Product Change Notification / CADA-20GQNA115

CCB 4827 Final Notice: Qualification of MTAI as a new assembly site for selected LAN925xx and LAN9353 device families available in 64L QFN (9x9x0.9mm) package.

**CCB 4827**  
**Pre and Post Change Summary**  
**PCN #: CADA-20GQNA115**

# LEAD FRAME COMPARISON

## ASE

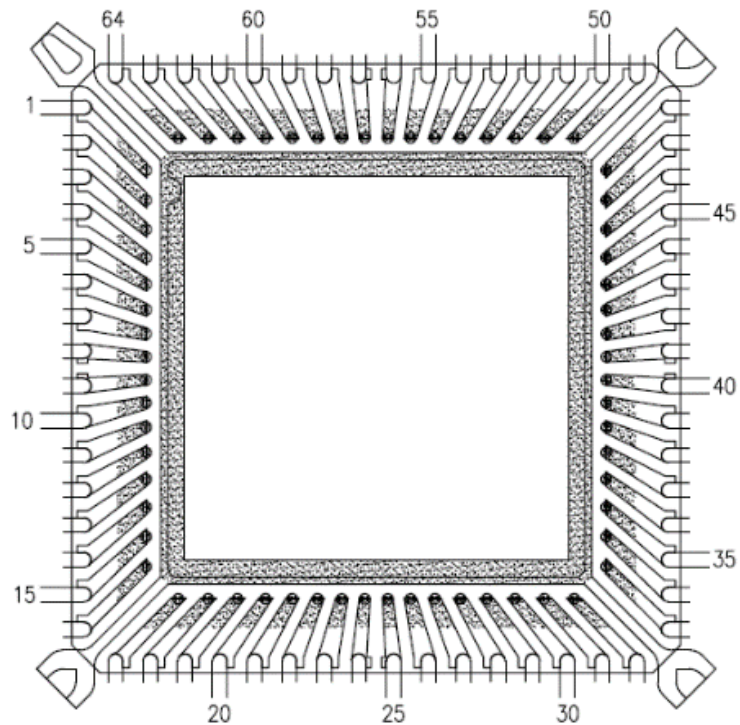
Lead frame Paddle Size

287x287mils

## MTAI

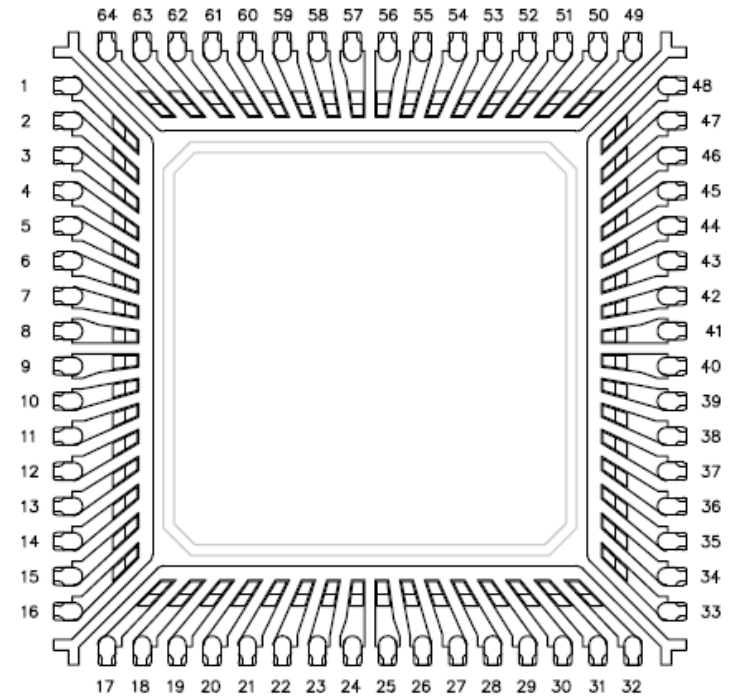
Lead frame Paddle Size

244 x 244mils
